BRUNSWICK STEAM ELECTRIC PLANT, UNIT NOS. 1 AND 2
DOCKET NOS. 50-325 AND 50-324
LICENSE NOS. DPR-71 AND DPR-62
IE BULLETIN 80-11, MASONRY DESIGN
REQUEST FOR ADDITIONAL INFORMATION

REQUEST FOR ADDITIONAL INFORMATION

MASONRY WALL DESIGN

PART PLAN OF
TYPICAL DIESEL
GEN ROOM

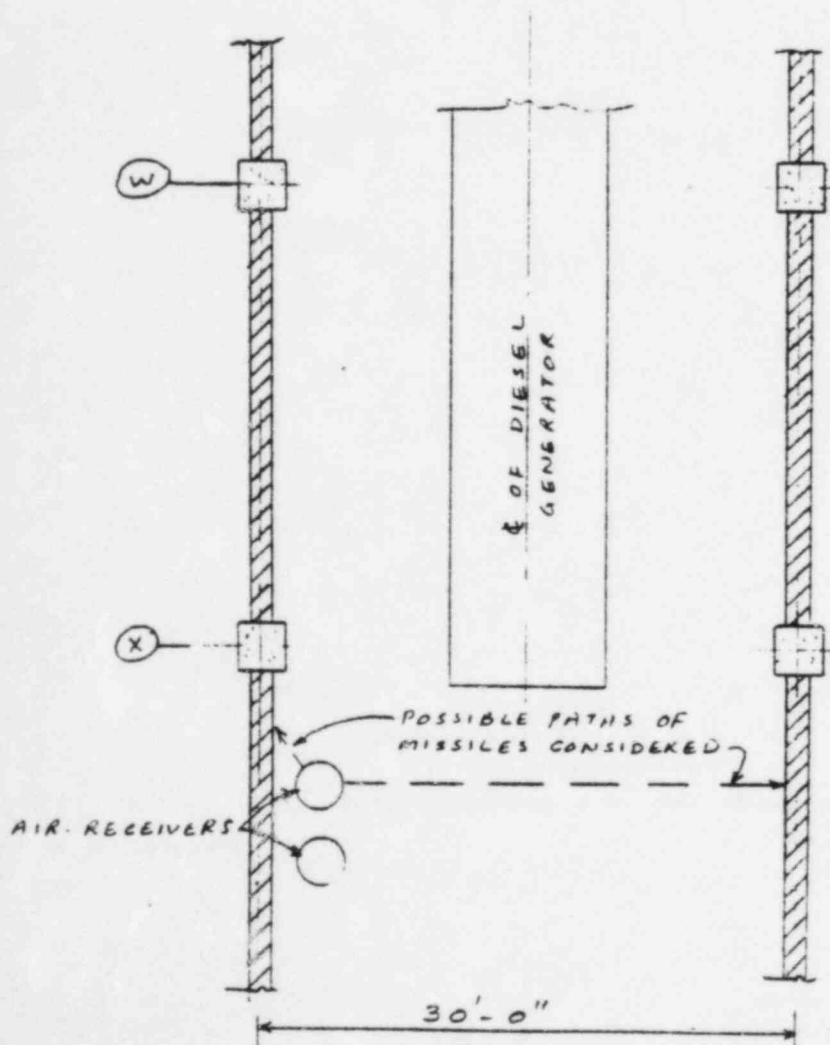
RAI 6d - Also, provide a sample calculation illustrating how these loads were treated in the analysis.

The sample calculation, Attachment RAI 6d, describes how impactive effects were considered. Both local and overall response was accounted for.

THESE WALLS SEPARATE THE DIESEL GENERATORS. IN EACH ROOM THERE ARE TWO AIR RECEIVERS WHICH CONTAIN COMPRESSED AIR AT 350 PSI (GAUGE) OPERATING PRESSURE USED FOR STARTING THE DIESEL GENERATORS.

THREE TYPES OF MISSILES HAVE BEEN POSTULATED.

1. A PLUG OF WT 1.38 LBS., 2 IN. DIA BECOMES LOOSE AND IS PROPELLED BY EXHAUSTING AIR
2. THE AIR RECEIVER IS PUNCTURED AND BECOMES A JET-PROPELLED MISSILE.
3. THE AIR RECEIVER EXPLODES INTO FRAGMENTS, A FRAGMENT IS IDEALIZED AS 2 IN. DIA CIRCULAR DISC.

Figure 2

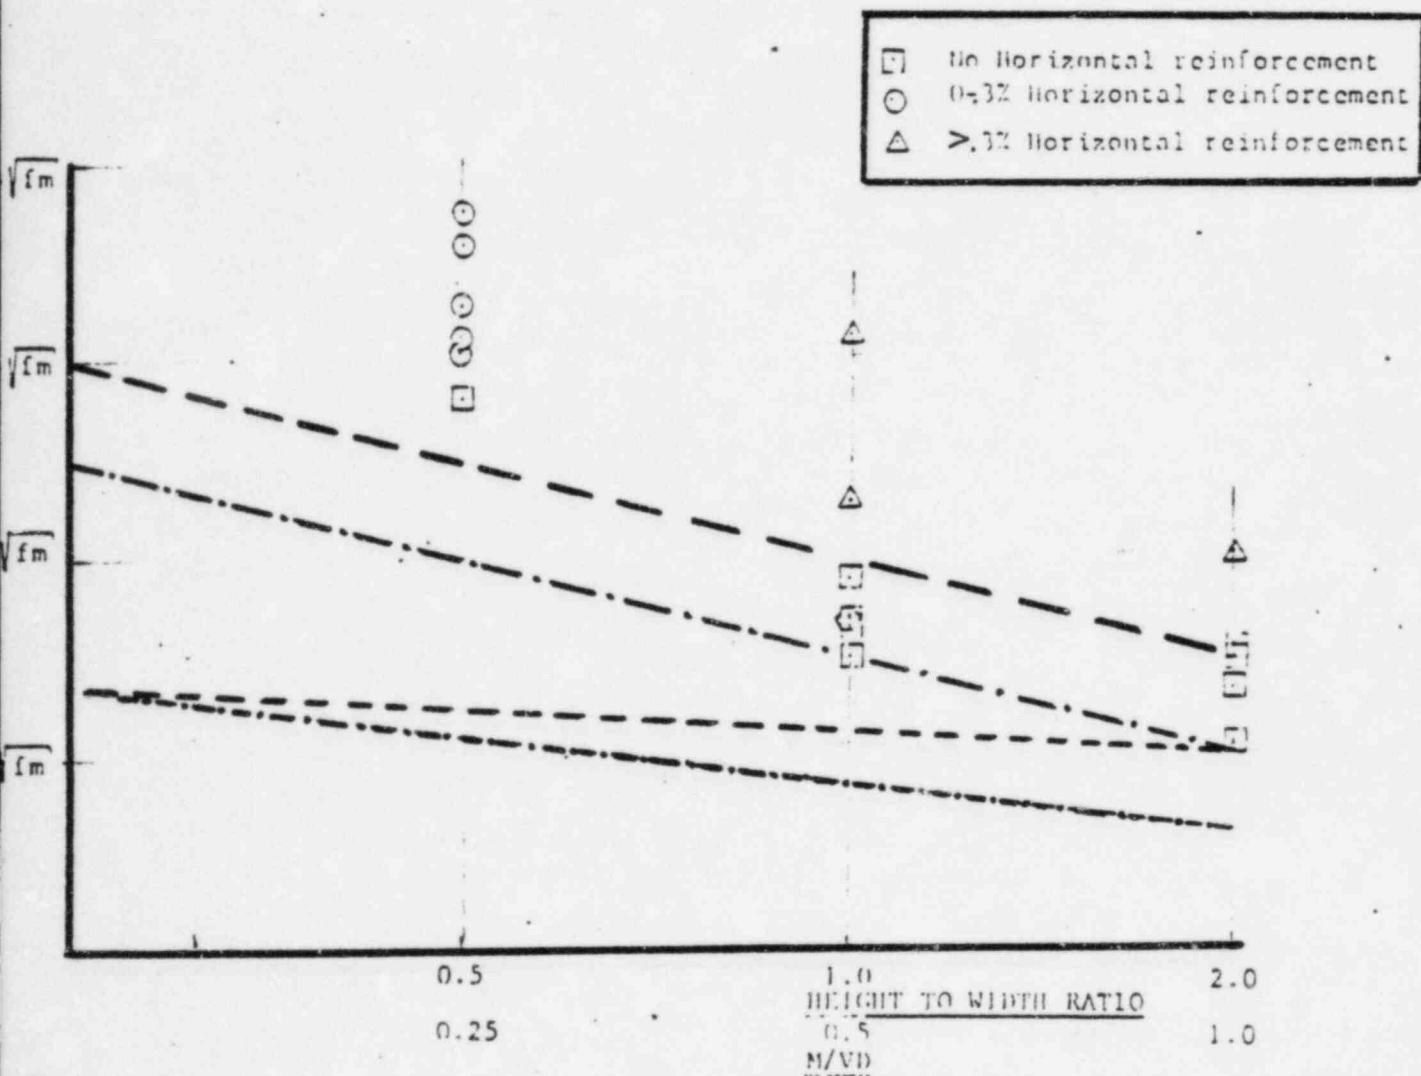
RAI 9b - If the Licensee intends to use any existing test data to justify these factors, the Licensee is requested to discuss the applicability of those tests to the masonry walls at the plant to the following areas:

- Lower Bound Ultimate with Horizontal Reinforcement
- Lower Bound Ultimate with no Horizontal Reinforcement
- Code Allowable with no upper limit. Reinforcement takes shear
- Code Allowable with no upper limit. Masonry takes shear

DESIGN OF SUITABLE FIX FOR Wall 4a

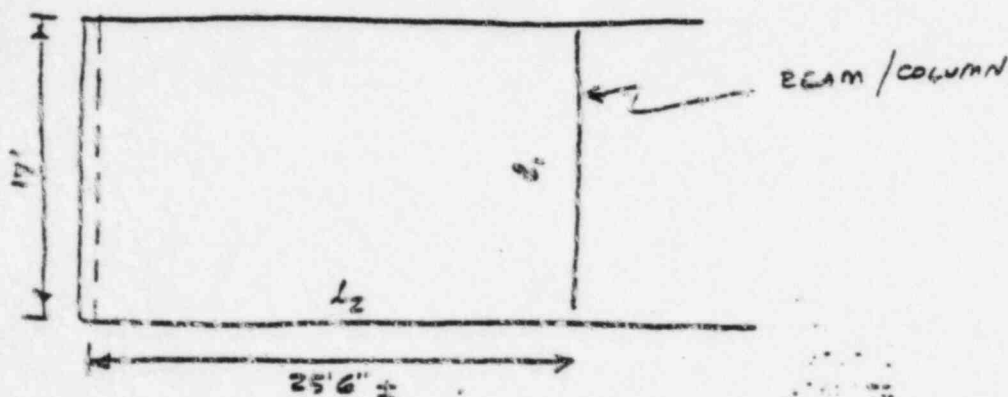
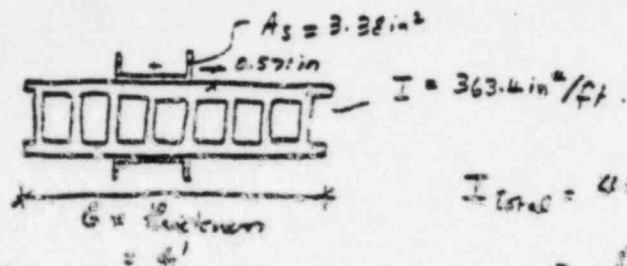
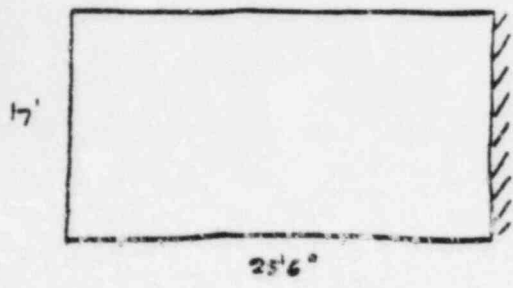
RAI 13b - Also, provide sample calculations to illustrate that the modified walls will be qualified under the working stress design condition.

ADD CHANNELS ON BOTH SIDES OF WALL TO CREATE ADDITIONAL SUPPORTS THAT WOULD MAKE THE WALL SPAN TWO-WAY.

BEAM SHOULD HAVE SUFFICIENT STIFFNESS RELATED TO WALL TO MAKE THE WALL SPAN HORIZONTALLY AS WELL.

CALCULATE MOMENT OF INERTIA OF A PAIR OF CHANNELS BOLTED TOGETHER. TRY $C2 \times 15.9$. ALSO ASSUME EX THICKNESS OF WALL IS EFFECTIVE AS PART OF BEAM
